**NOTICE OF A REGULAR MEETING
BONDURANT PLANNING AND ZONING COMMISSION
JUNE 24, 2021**

TITLE: RESOLUTION NO. PZ-210624-12 - Considering recommended approval of the Commerce Crossings Phase 2 site plan.

TITLE: RESOLUTION NO. PZ-210624-13 - Considering recommended approval of the Dvorak Preliminary Plat.

COMMERCE CROSSINGS DEVELOPMENT - PHASE 2 SITE PLAN

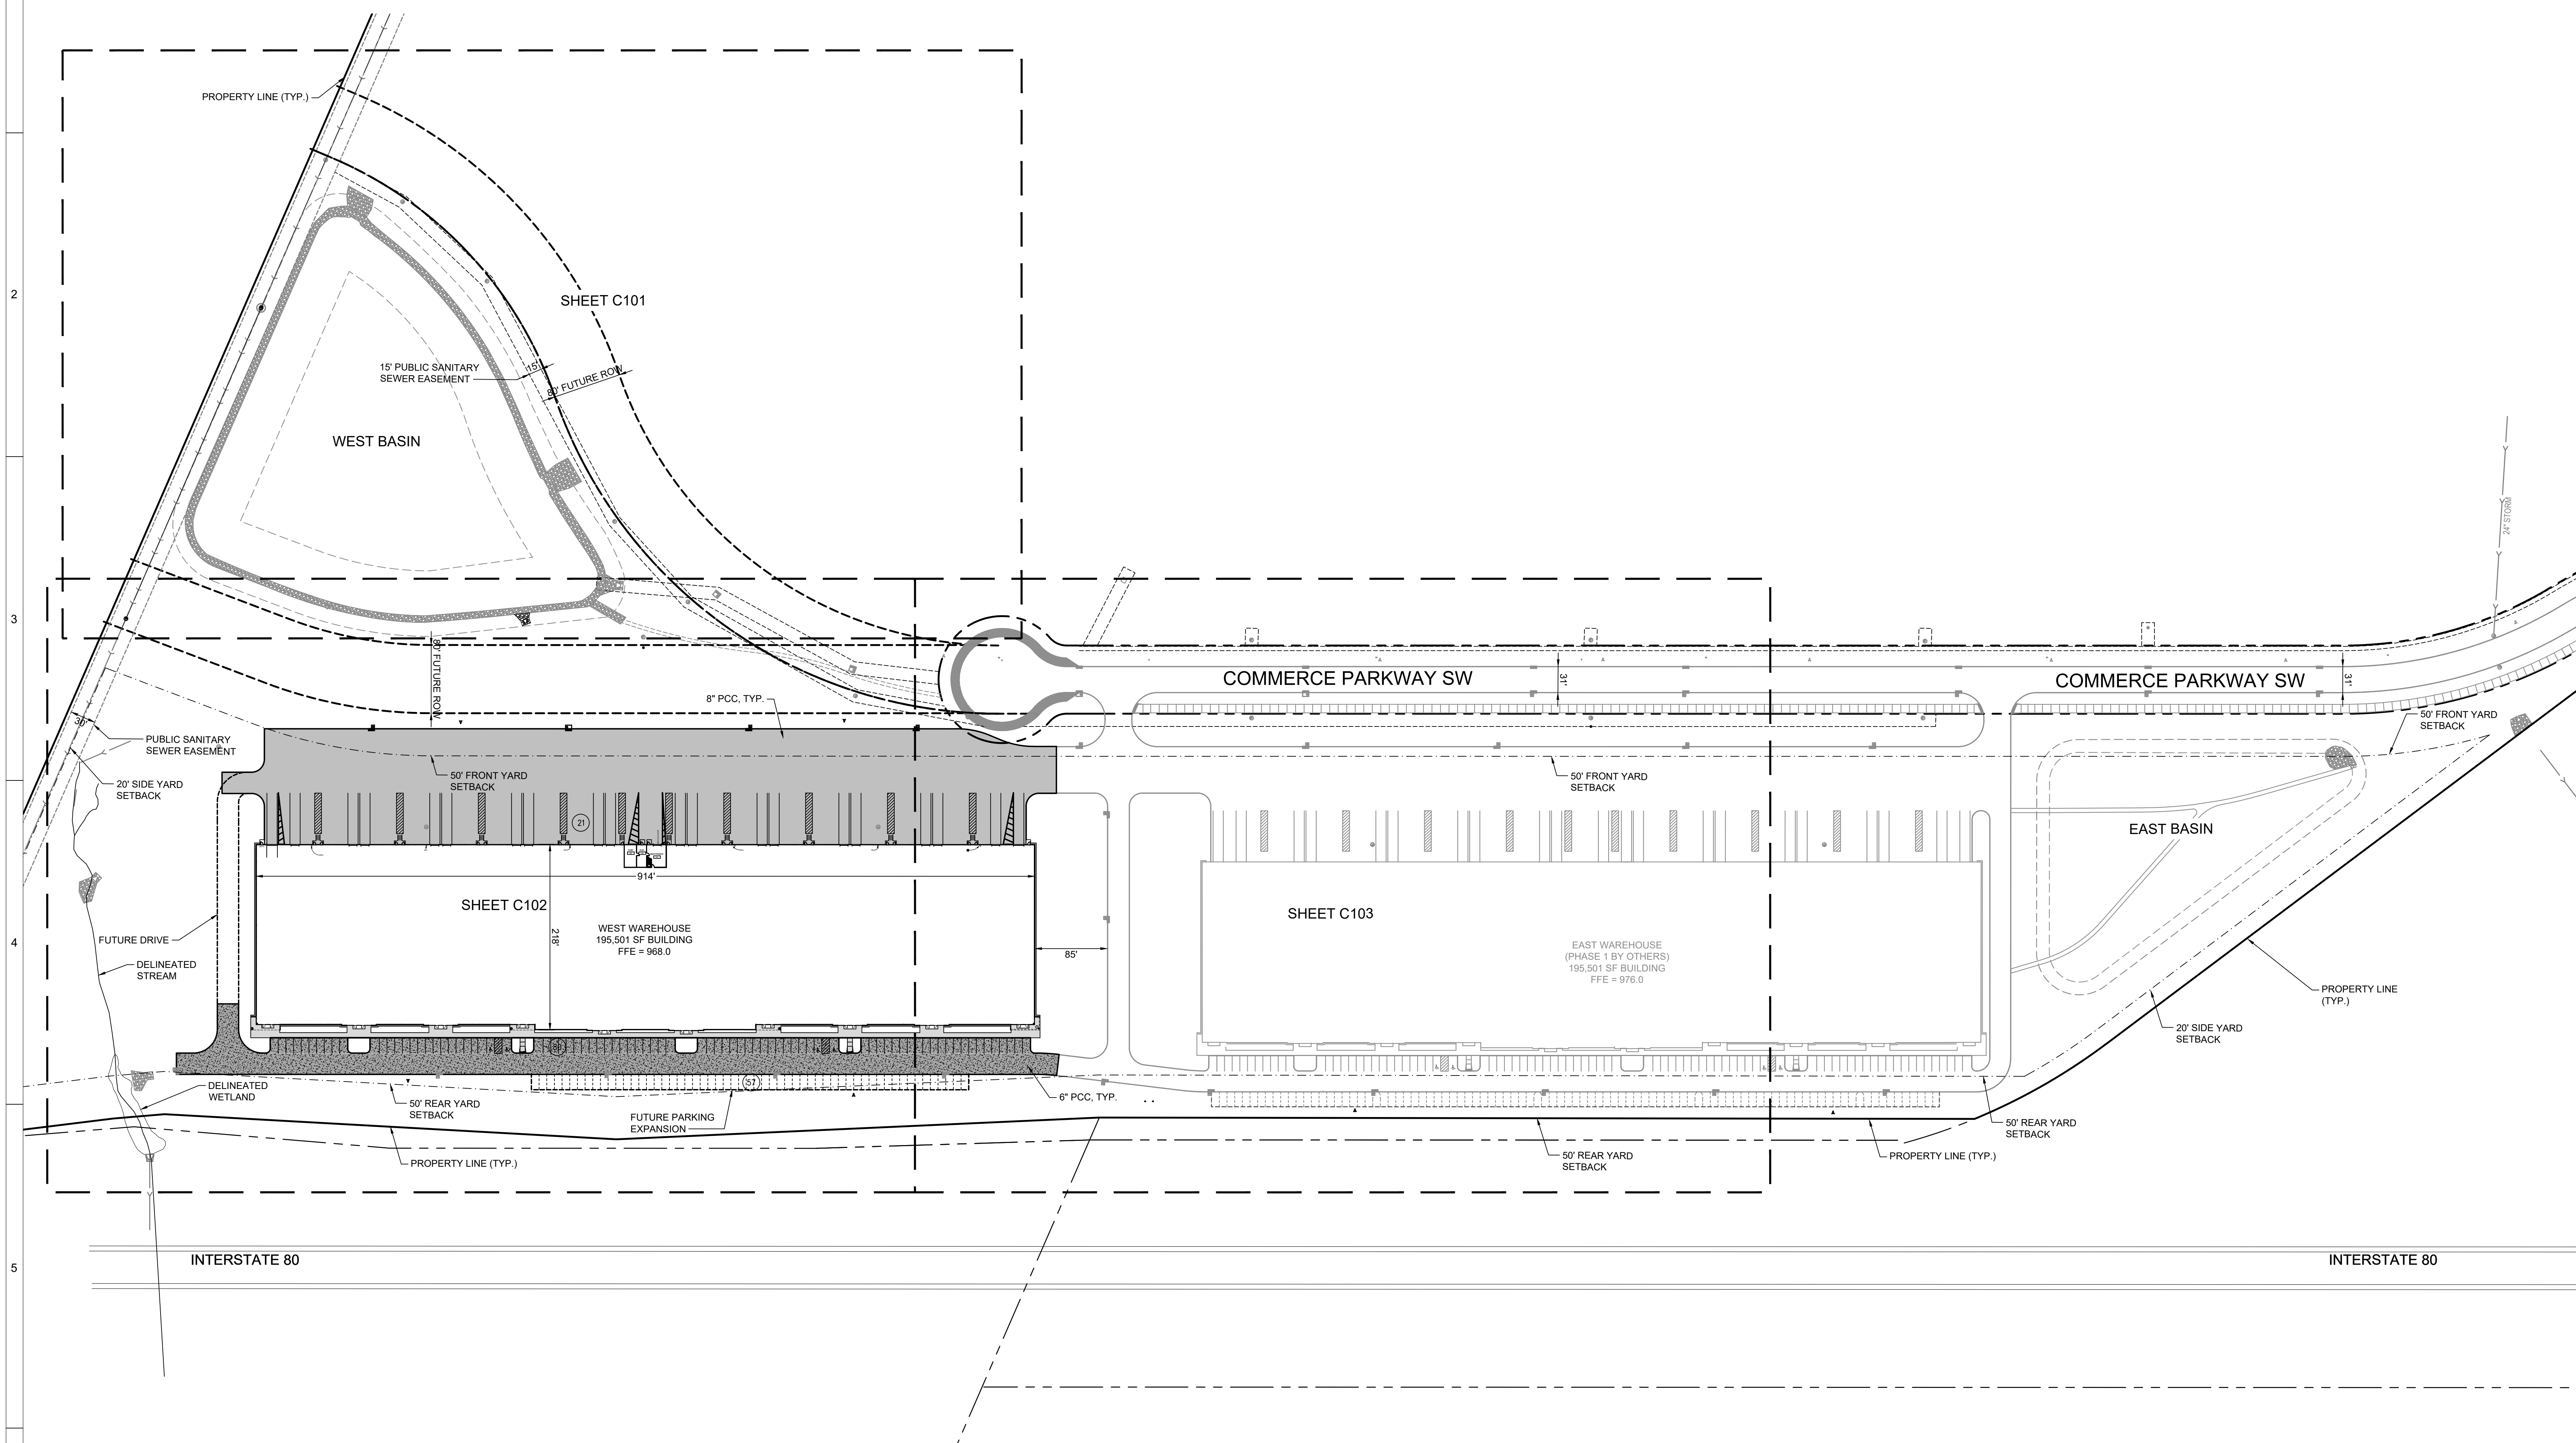
1. This Phase 2 area was included as part of the Phase 1 stormwater management report.
2. A small portion of this site touches the 100-year floodplain. The site plan should be updated to show this floodplain boundary.
3. This site falls within close proximity to a Type 3 stream buffer area. Site plan to be updated to show the City's Type 3 area to ensure compliancy.
4. Page C302 and C303 contain the required utility plan. Related to this – this site is situated within the City's Wolf Creek Sanitary Sewer Connection Fee District.

1. Pages L100-102 contain the required landscaping plan. The cover page also includes information on number of trees proposed. The landscaping plan will need to be updated so that the following is met for this development:

1. General trees shall be required at the rate of one tree per 50' of frontage or one tree per six 6 parking, loading and stacking spaces provided on the site, whichever is greater.

2. Of the total number of required general trees, a minimum of one tree per fifty (50) feet of street frontage shall be planted in the required front yard setback. Related to this: trees shall be located no closer than four (4) feet to the public right-of-way

3. To confirm the parking lot islands are at least 5'-wide and contain at least 36 SF per tree.
 4. To confirm deciduous trees are at least 1 ¾ inch caliper.

1. Site plan to be updated to show location of 100-year floodplain on site.
2. Site plan to be updated to show location of the Type 3 Stream Buffer on site.

3. Site plan to be updated to show the following is met:
 - a. General trees shall be required at the rate of one tree per 50' of frontage or one tree per six 6 parking, loading and stacking spaces provided on the site, whichever is greater.

- b. Of the total number of required general trees, a minimum of one tree per fifty (50) feet of street frontage shall be planted in the required front yard setback. Related to this: trees shall be located no closer than four (4) feet to the public right-of-way.

- c. To confirm the parking lot islands are at least 5'-wide and contain at least 36 SF per tree.
 - d. To confirm deciduous trees are at least 1 ¾ inch caliper.

4. Site plan to be updated to show there will be adequate treatment or screening of loading docks, loading areas, and garbage dumpsters from any public street and adjoining properties. Typical screening methods include berms and/or living screen.
